MATANUSKA-SUSITNA BOROUGH

ABBREVIATED PLAT AGENDA ASSEMBLY CHAMBERS 350 EAST DAHLIA AVENUE, PALMER

STAFF REVIEW AND RECOMMENDATIONS
PUBLIC HEARING
AUGUST 5, 2026

ABBREVIATED PLAT: GOLDENBERG
LEGAL DESCRIPTION: SEC 09, T16N, R02E S.M., AK
PETITIONERS: ARI GOLDENBERG
SURVEYOR/ENGINEER: HANSON LAND SOLUTIONS
ACRES: 5.51 +/- PARCELS: 2
REVIEWED BY: CHRIS CURLIN CASE #: 2026-079

A PLAT OF
GOLDENBERG SUBDIVISION
A SUBDIVISION OF
LOTS 18 & 19, BLOCK 1 HERITAGE PARK SUBD. (PLAT 77-229)
AND
LOT 1, U.S. SURVEY 3242
ANCHORAGE RECORDING DISTRICT
THIRD JUDICIAL DISTRICT
STATE OF ALASKA
LOCATED WITHIN
SW 1/4 SEC. 9, T.16N. R.2E. SM, AK
CONTAINING 5.51 ACRES MORE OR LESS

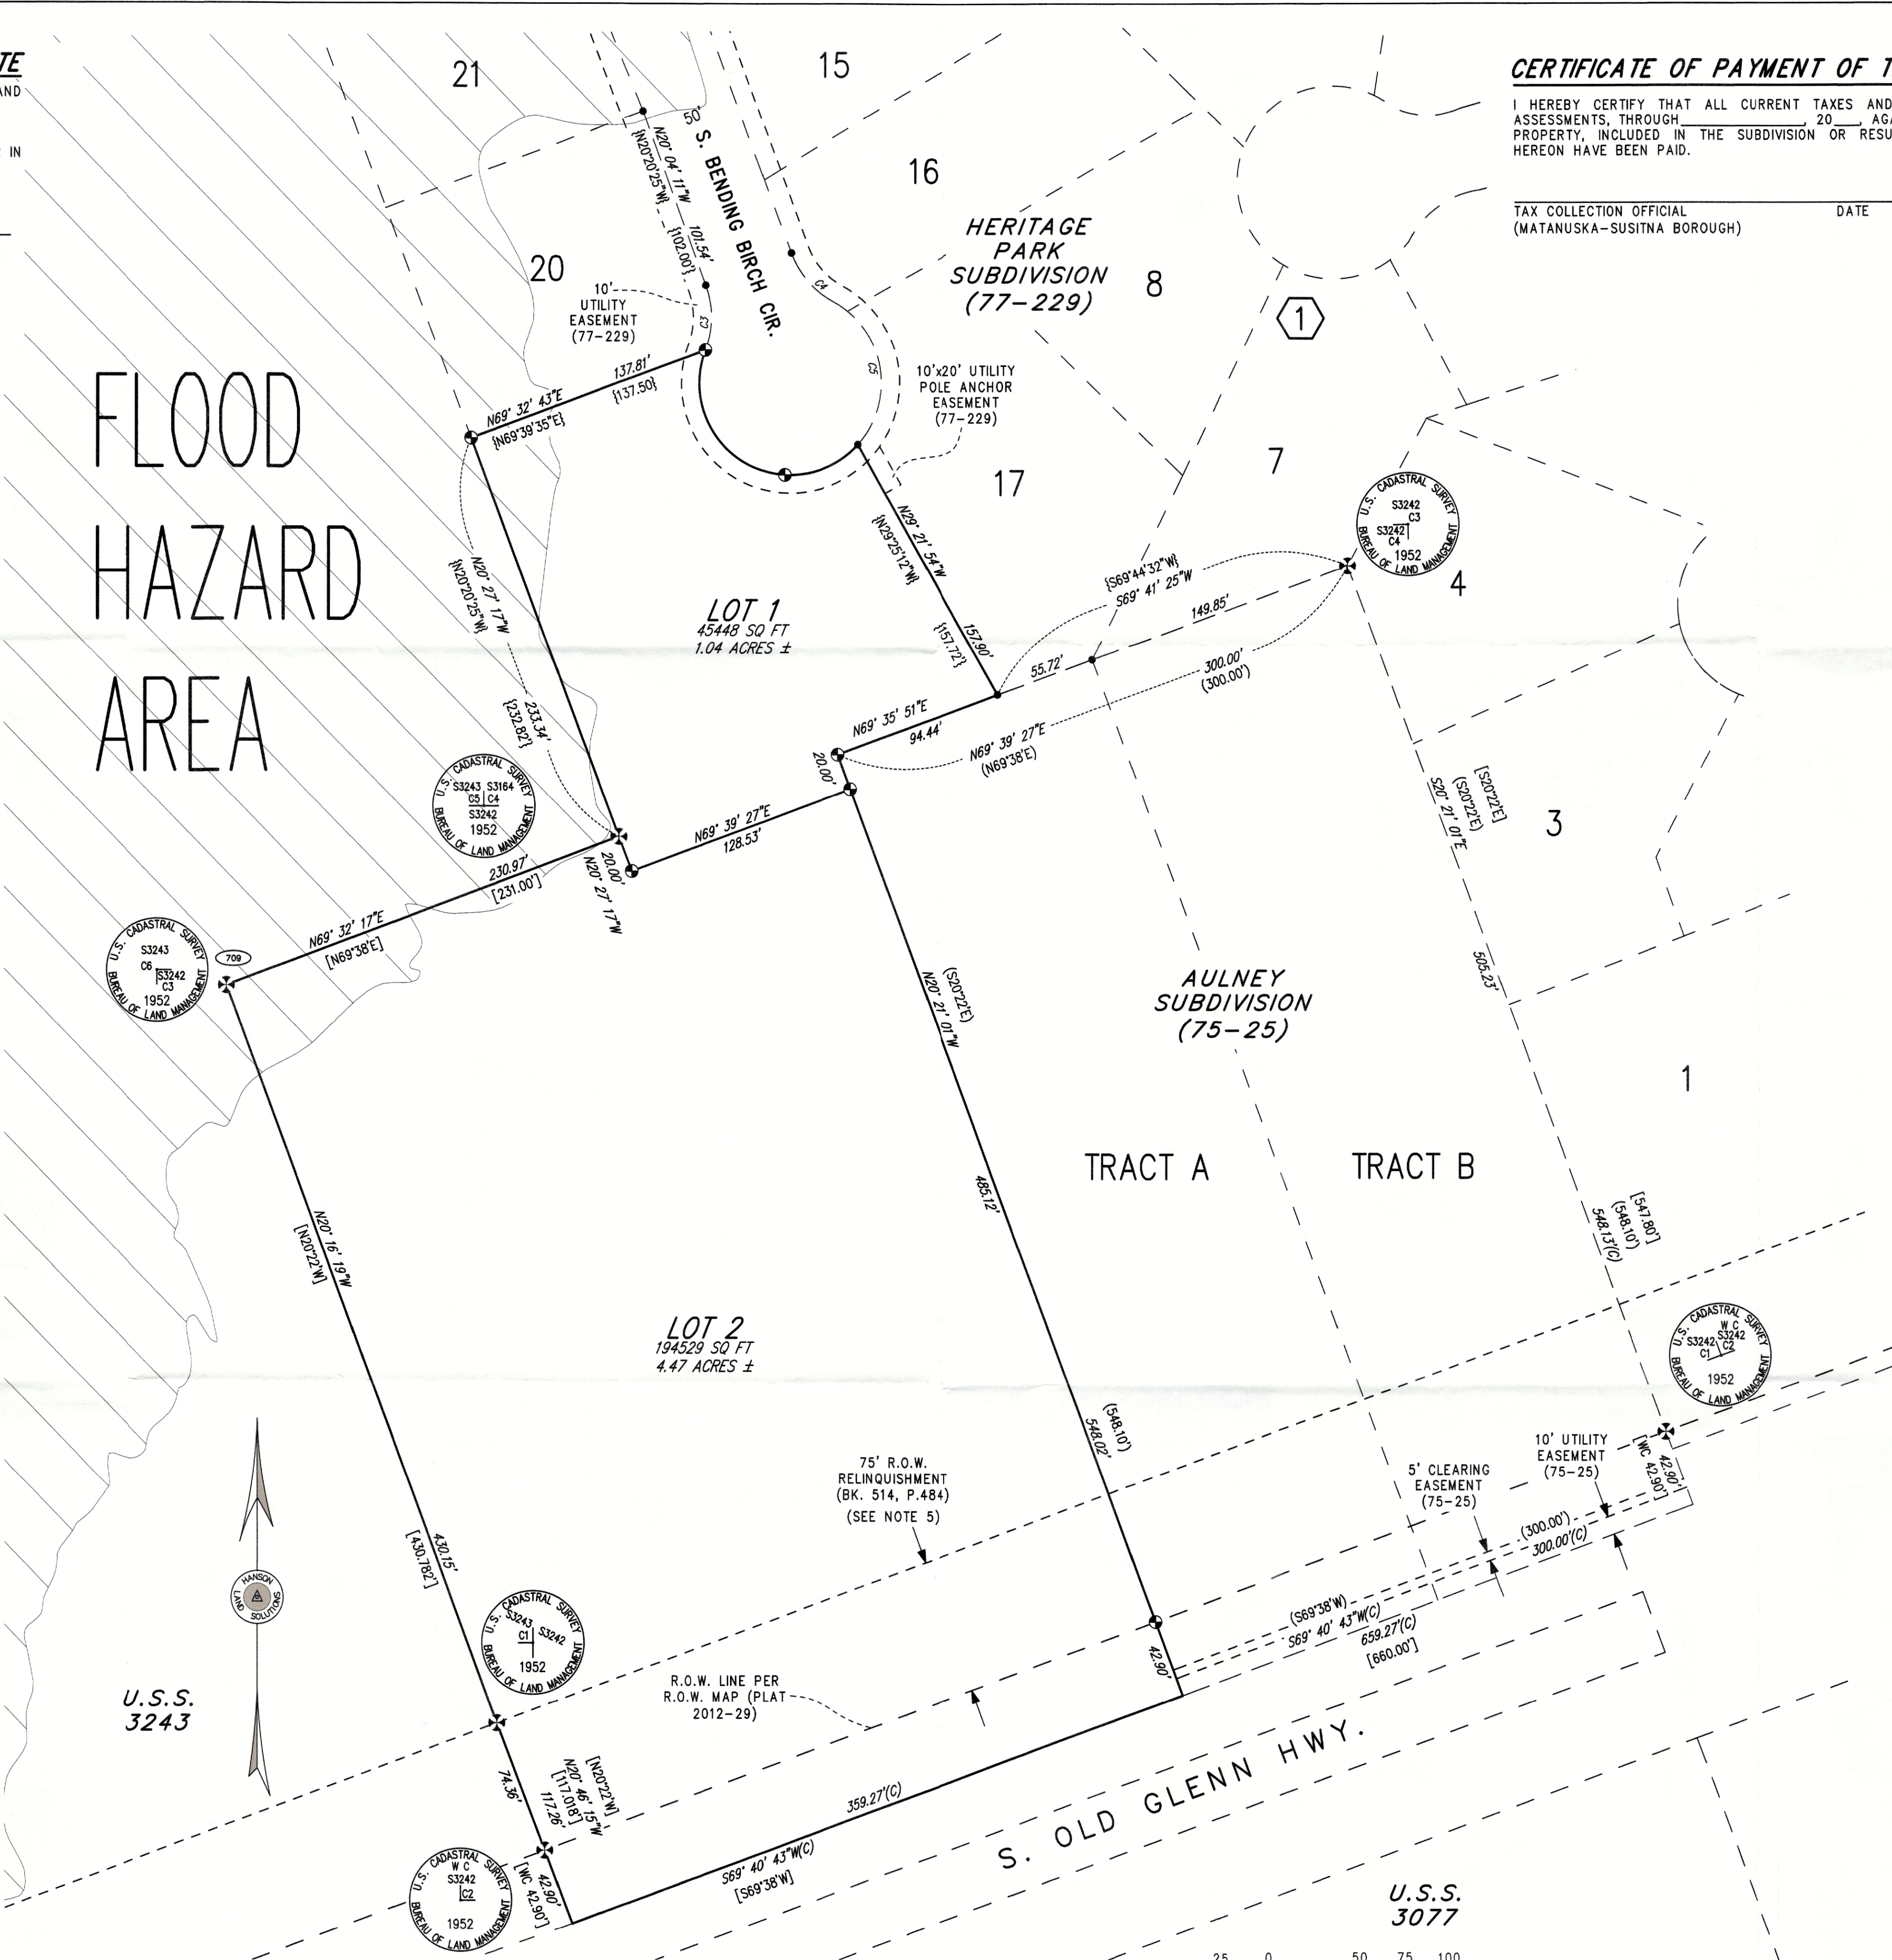
Remove dashed lines around "S. OLD GLENN HWY" on Agenda Plat

- **GC 02 Goldenberg; Plat #77-229 and USS 3242 (Old Glenn Highway MP 5.5)**
 - No objections to lot line changes.
 - One access to the Old Glenn Highway for Lot 2 will be allowed. Subsequent development of lots will require shared access.

- Add plat note: "One access to Old Glenn Highway for Lot 2" or similar.
 - Remove dashed lines around "S. OLD GLENN HWY" on Agenda Plat
 - Apply for driveway permit for access to Old Glenn Highway. Driveway permits and Approach Road Review can be applied for at DOT&PF's online ePermits website: <https://dot.alaska.gov/row/Login.po>. Please contact Gabe Kutcher in DOT&PF's ROW Property Management division at 907-269-0691 if you have any questions.

Add plat note: "One access to Old Glenn Highway for Lot 2" or similar.

Staff notes this is condition #4.

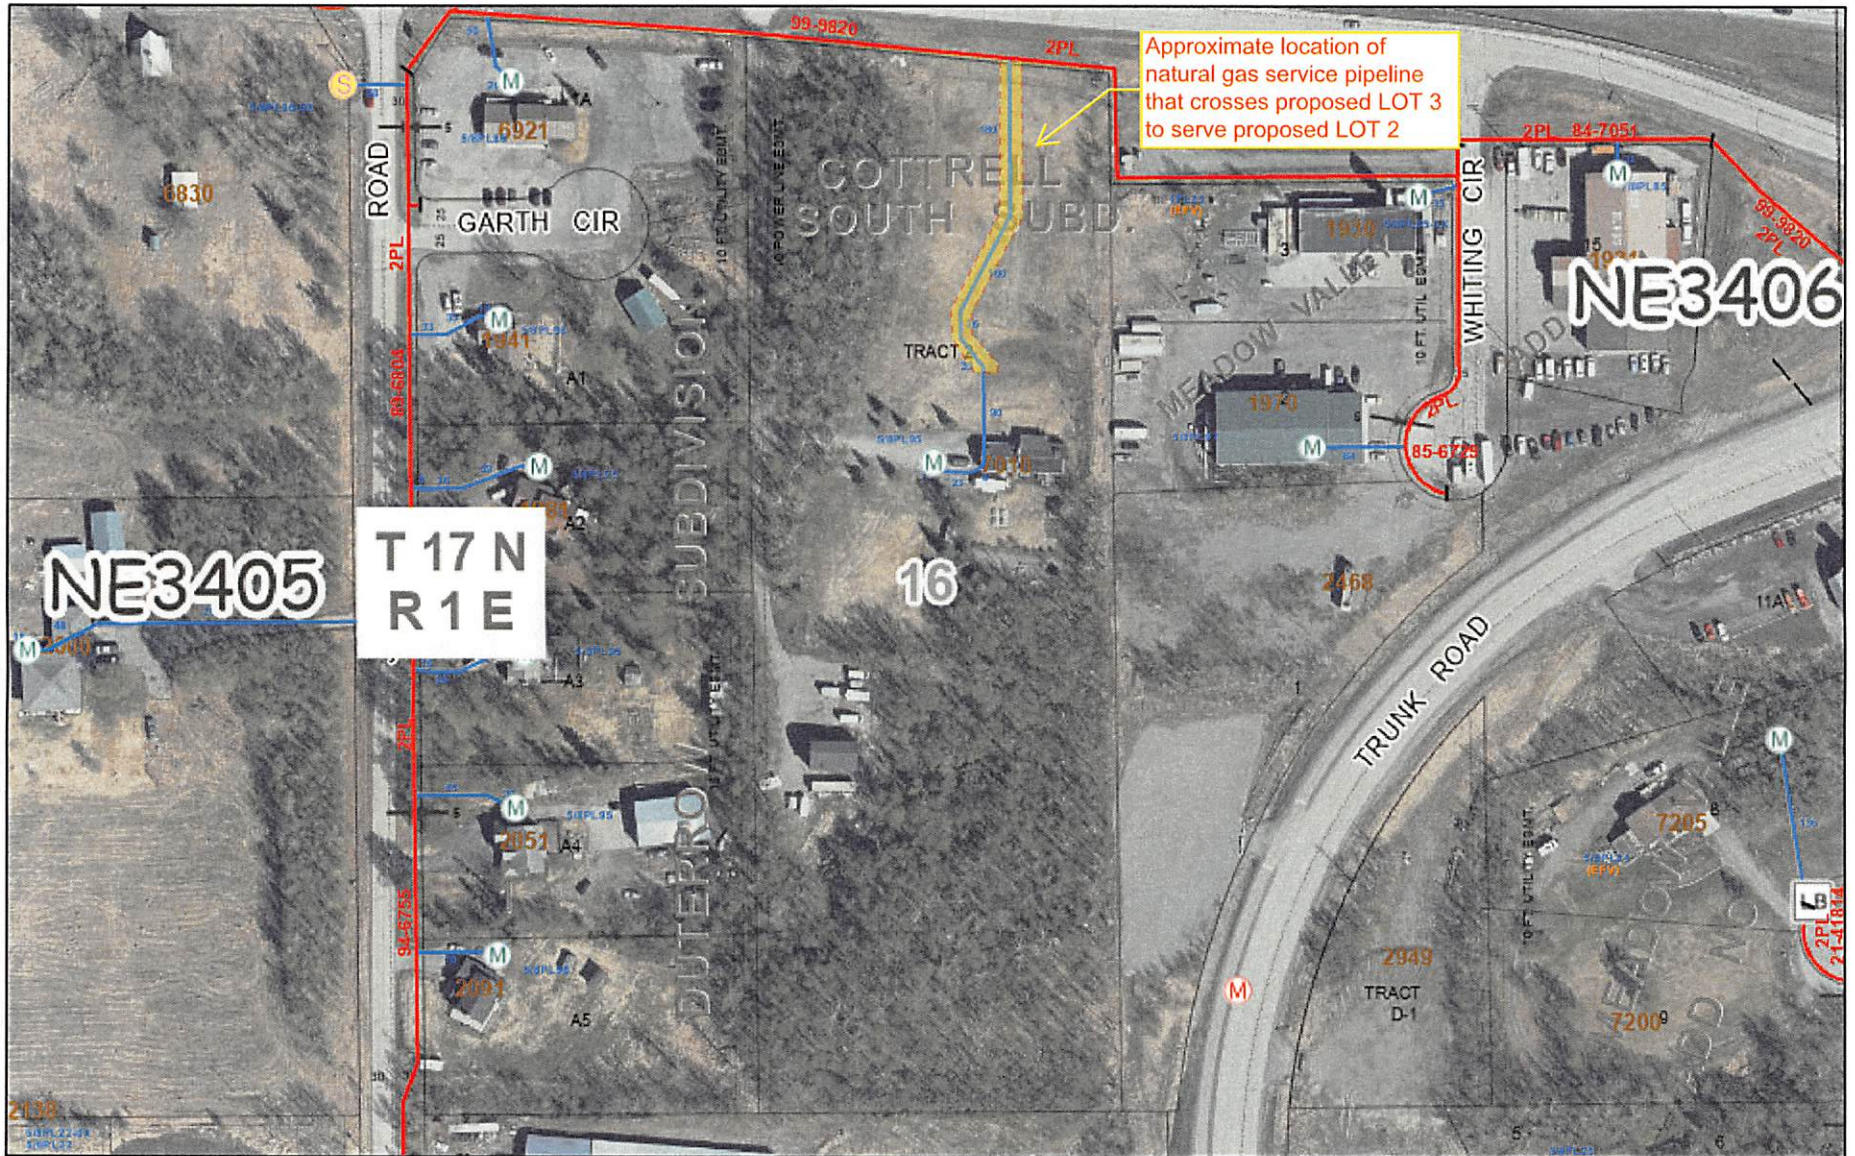
ENSTAR Natural Gas Company, LLC (ENSTAR) has reviewed abbreviated plat Pioneer Peak Vista (MSB 2026-080) and advises that ENSTAR has existing natural gas service pipeline that crosses proposed LOT 3 to serve proposed LOT 2. Attached is a depiction for your reference. ENSTAR objects to this plat unless one of the following scenarios is met:

1. Grant ENSTAR a ten feet (10 FT) wide natural gas easement centered over the existing natural gas service pipeline within proposed LOT 3 and serving proposed LOT 2.
2. Dedicate a ten feet (10 FT) wide natural gas easement centered over the existing natural gas service pipeline within proposed LOT 3 and serving proposed LOT 2

DRAWN BY GLO/KLY	DATE 5/28/26	DRAWING 2026-7/PioneerPeakVista
CHECKED BY GLO	SCALE 1 INCH = 60 FEET	SHEET 1 OF 1

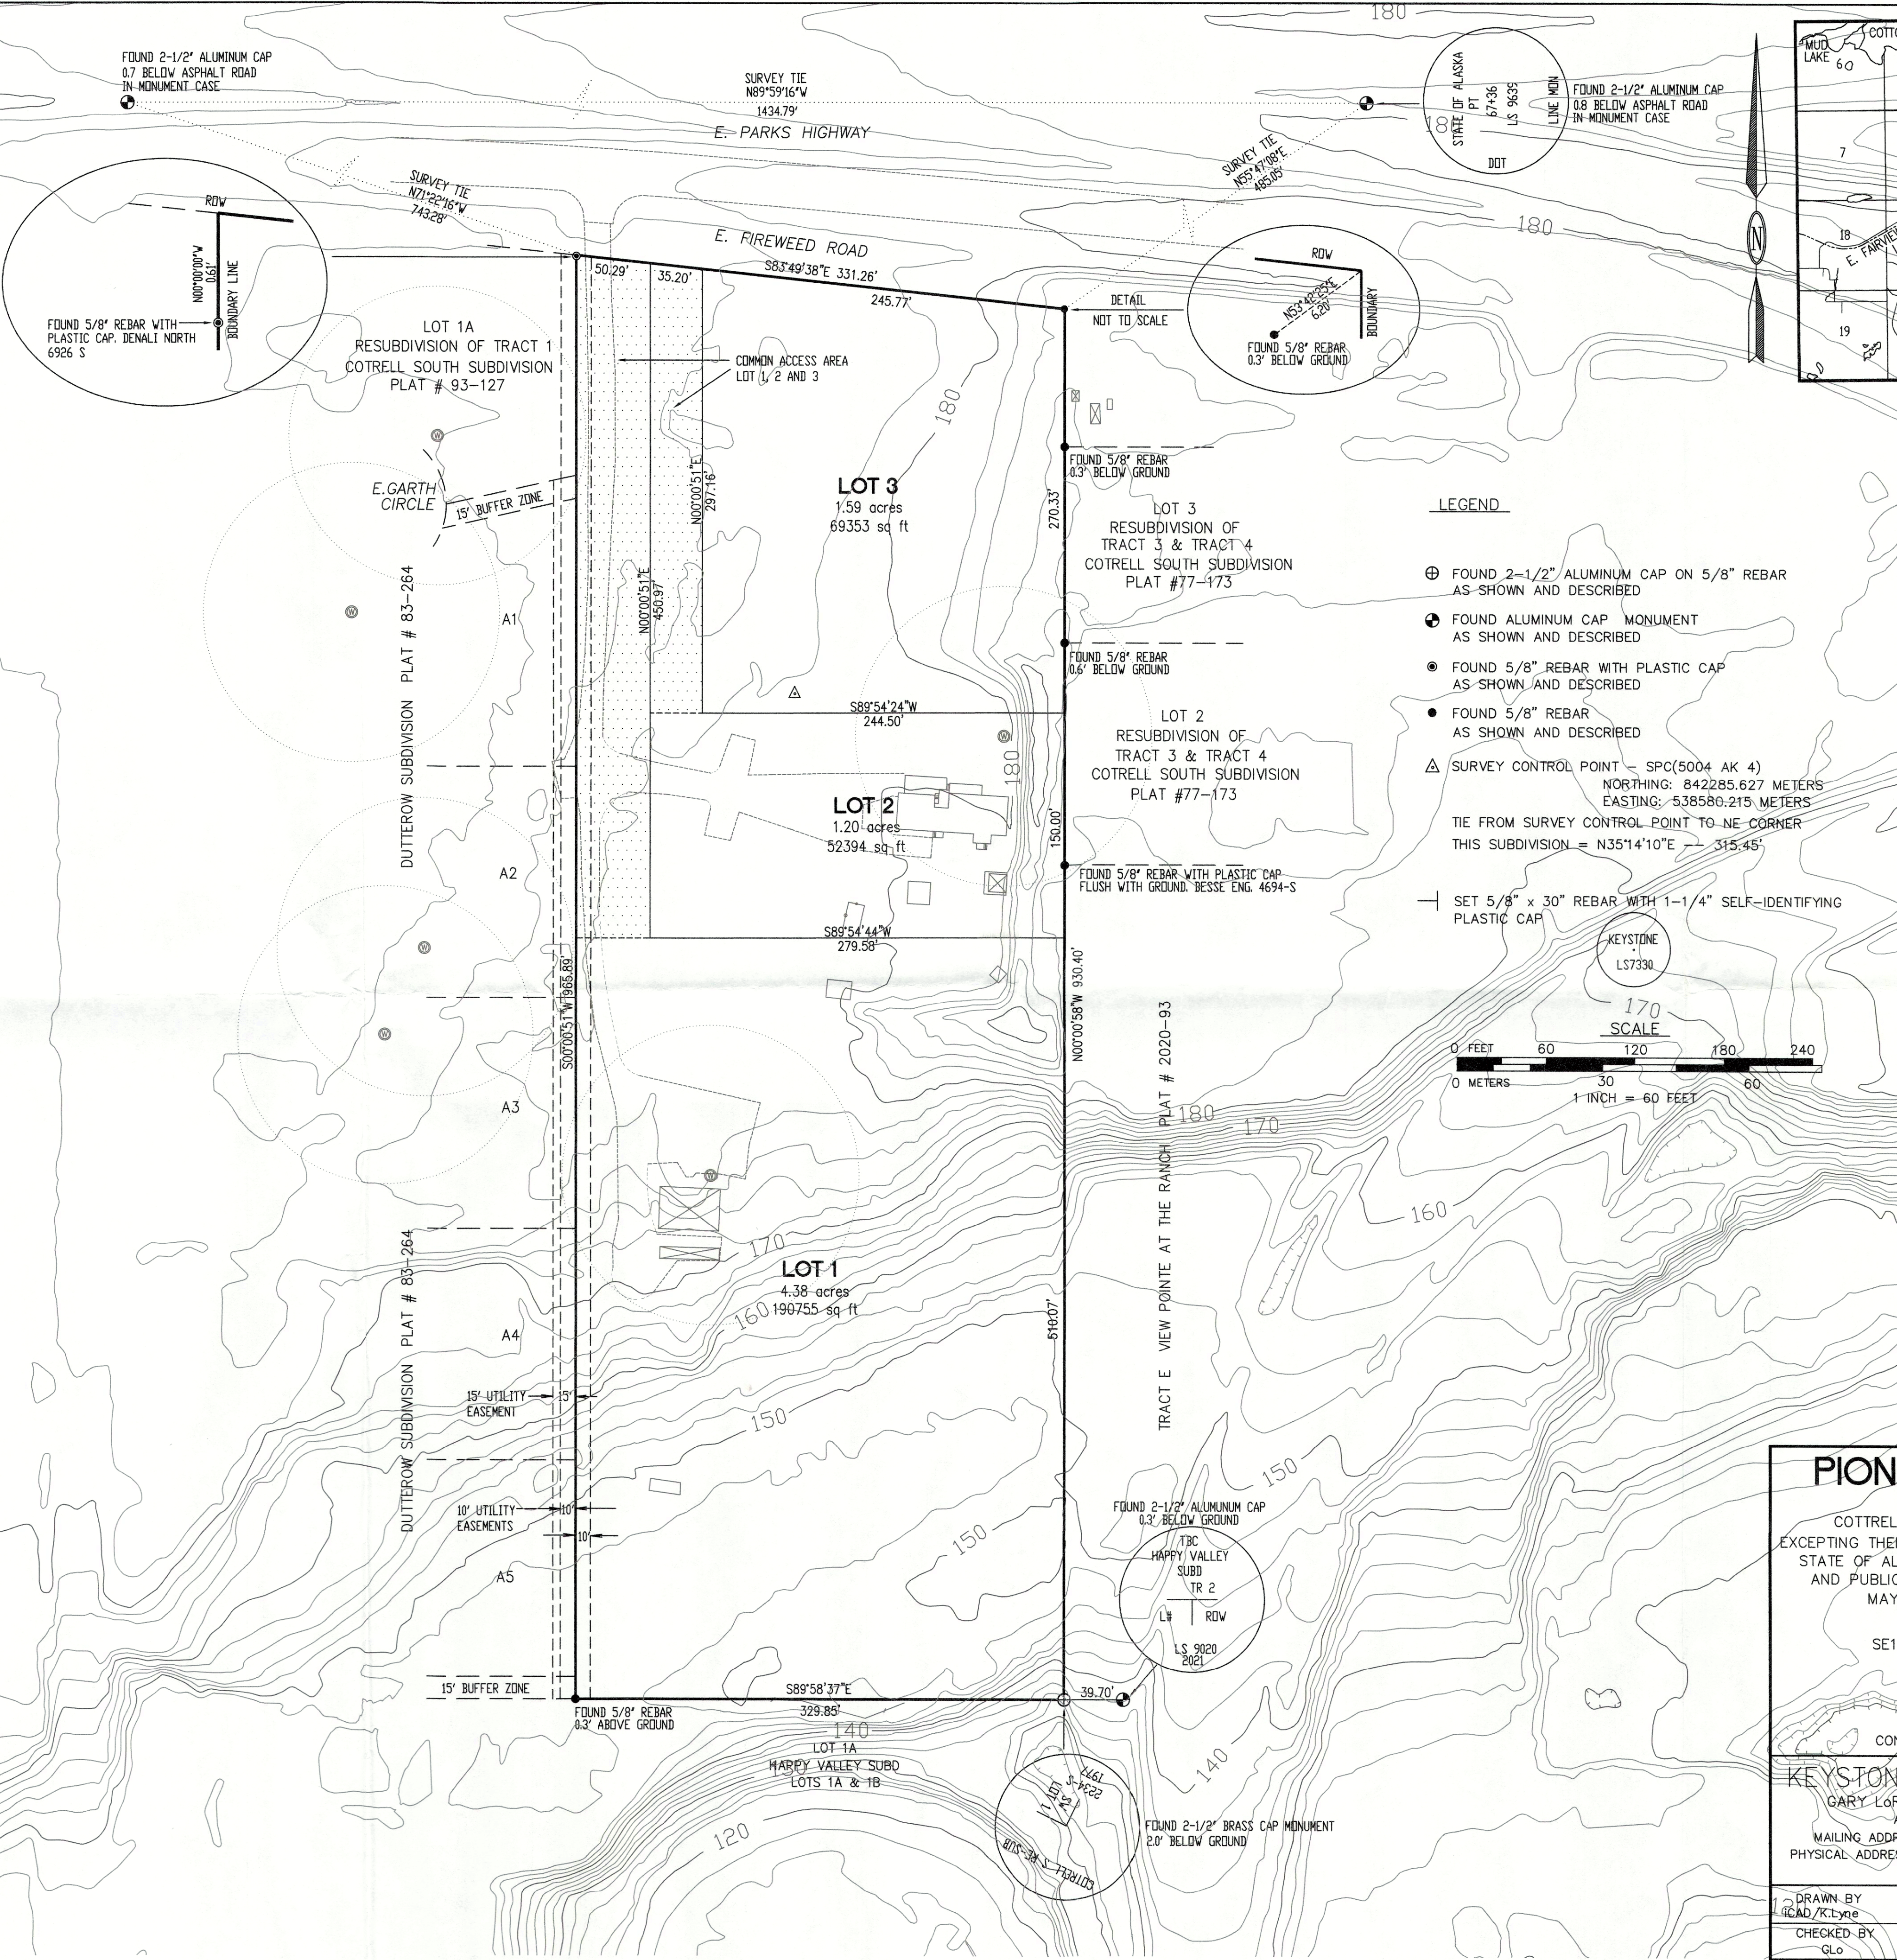
- **Pioneer Peak Vista; WA 10 Cross Country Church; Plat #72-43 (Fireweed Road)**
 - No objection to lot division.
 - Shared access easement required.
 - Required to add plat note: "Shared access to Fireweed Road for Lots 1-3."

- Apply for shared driveway permit. Driveway permits and Approach Road Review can be applied for at DOT&PF's online ePermits website: <https://dot.alaska.gov/row/Login.po>. Please contact Gabe Kutcher in DOT&PF's ROW Property Management division at 907-269-0691 if you have any questions.

3. Pay postage and advertising fees.
4. Add a plat note stating: "Lots 1, 2, & 3, to share a single access to E. Fireweed Road unless otherwise authorized by the permitting authority."

5. Apply for a shared driveway permit from ADOT&PF for the existing access to E. Fireweed Road. Provide Platting staff a copy of the submitted driveway permit application.

6. Grant additional common access easement on the western boundary of Lot 2 allowing for a common access area with a overall width greater than 75'.
7. Show all easements of record on final plat.
